EUGENE PLANNING COMMISSION

AGENDA ITEM SUMMARY

Subject: Infill Compatibility Standards for Multi-Family Developments (City File CA 11-2)

MULTI-FAMILY OPEN SPACE STANDARDS

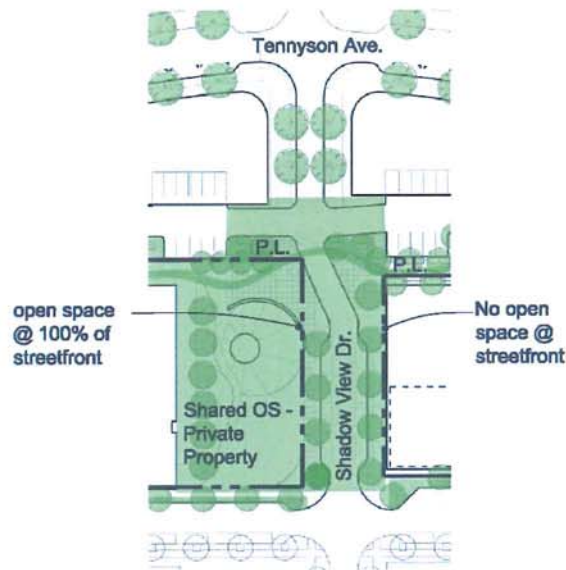
Requiring common open space on a front property line may hinder creative designs especially where a multi-family development is integrated into a mixed use urban center. In areas with the /ND Nodal Development overlay, special consideration should be given to allow the PUD process to guide the master plan instead of strict standards.

Open Space provided within Mixed-Use PUD – large open space on one side of street, with development pushed to street front at opposite side. The illustration above depicts a future phase of Crescent Village containing an urban plaza on the east side of Shadow View and high density housing on the west side. View in sketch is looking south.

**Figure
9.5500 (9)(a)**

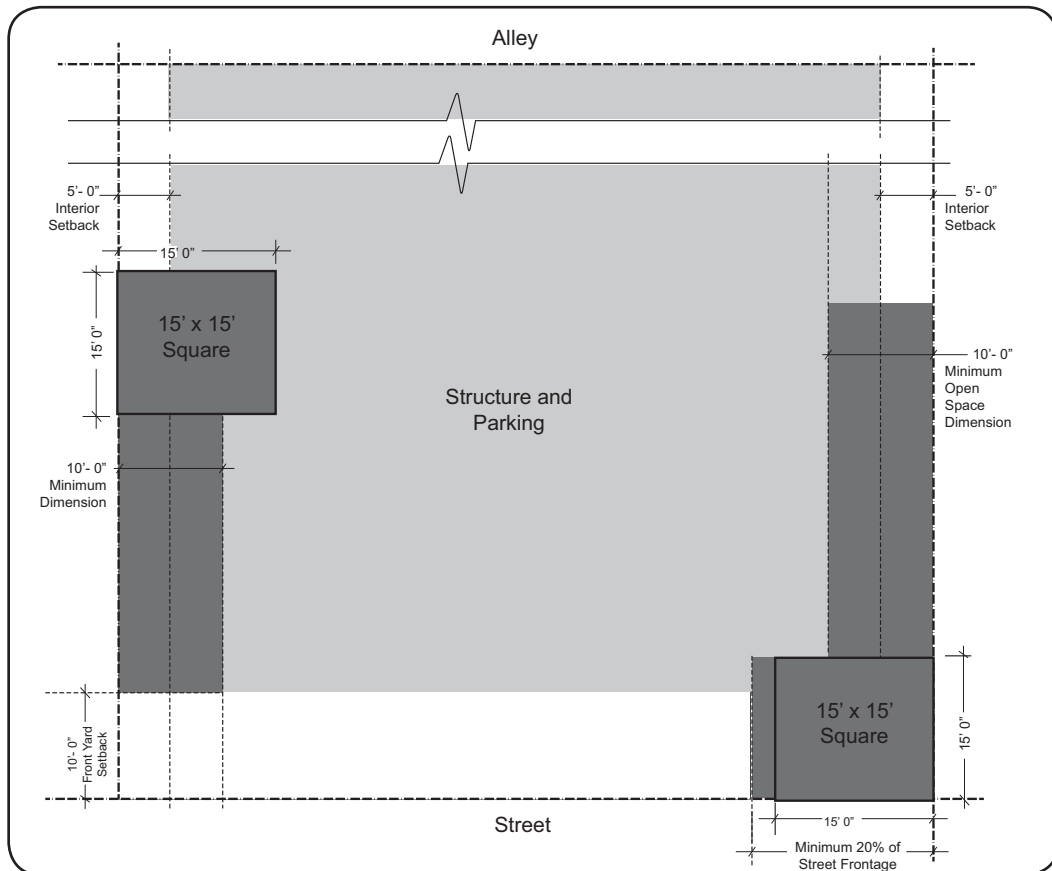
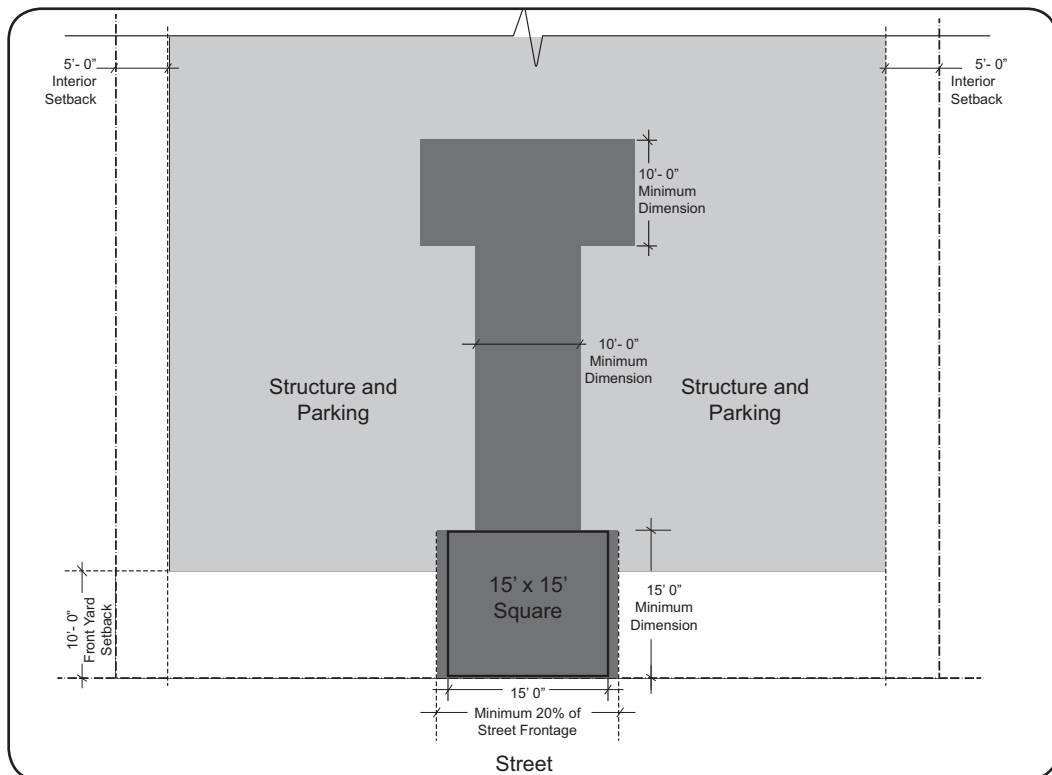
EC 9.5500(9)(a)2.a. & b.	See above	See above.	Address internal conflict between EC 9.5500(9)(a)2.a. requiring a 15 foot by 15 foot square for any common open space and EC 9.5500(9)(a)2.b. allowing a minimum dimension of common open space of 10 feet outside the front yard setback. Provide a figure for situations where there is no required front yard setback.	None.	Staff does not believe there is an internal conflict. If common open space is required, the minimum area of any open space must be 225 square feet and consist of a 15 foot by 15 foot square. If more open space is required, it can be provided in the front yard setback (15 foot minimum dimension) and/or outside of the front yard setback (10 foot minimum dimension). The intent is for the 10 foot portion must be connected to the 15 foot by 15 foot portion. Given the relatively few instances where these standards will apply in a zone with no minimum required front yard setback, staff does not recommend creating a new figure. The following zones have a minimum front yard setback of 0-feet: C-2, C-3, and several of the special areas zones for mixed use developments, including Chase, Royal, Whiteaker and Walnut. As noted above, the multi-family standards are not typically in C-3. In C-2, if the ground floor of a building is in nonresidential use, then the project is exempt from the multi-family standards.

Figure
9.2751 (8)

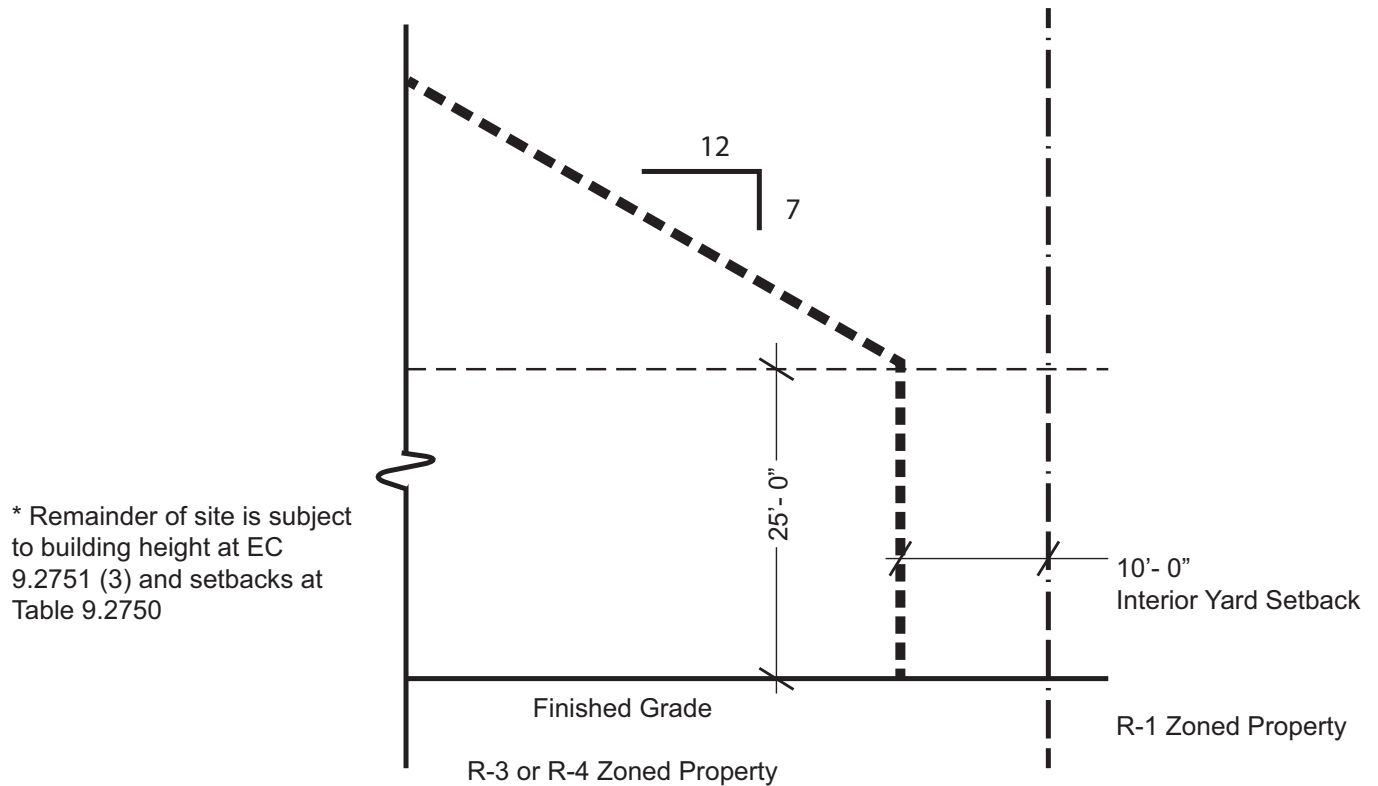
EC 9.2751(8)	See above.	See above.	None.	Introduced Option 3: Require 10 foot setback and change sloped setback to a 10:12 pitch beginning at a height of 20-feet above grade. Introduced Option 3a: Require 5 foot setback and changed sloped setback to setback to a 10:12 pitch beginning at a height of 20-feet above grade.	Staff supports either 2 or 3a over option 3. Staff does not support option 1.
EC 9.2751(8)	See above.	See above.	Do not require the 10 foot setback when the R-3 or R-4 property abuts an alley. The alley already provides a minimum of a 14 foot setback plus the 5 foot required setback. If the R-1 developed lot is built with the required 5 foot setback to the alley the buildings are now 24 feet apart.	None.	Staff supports addressing this issue by either changing Option 2 to allow for a 5 foot setback from an alley or by recommending Option 3a, which provides for a 5 foot setback from the property line and alley (instead of 10).
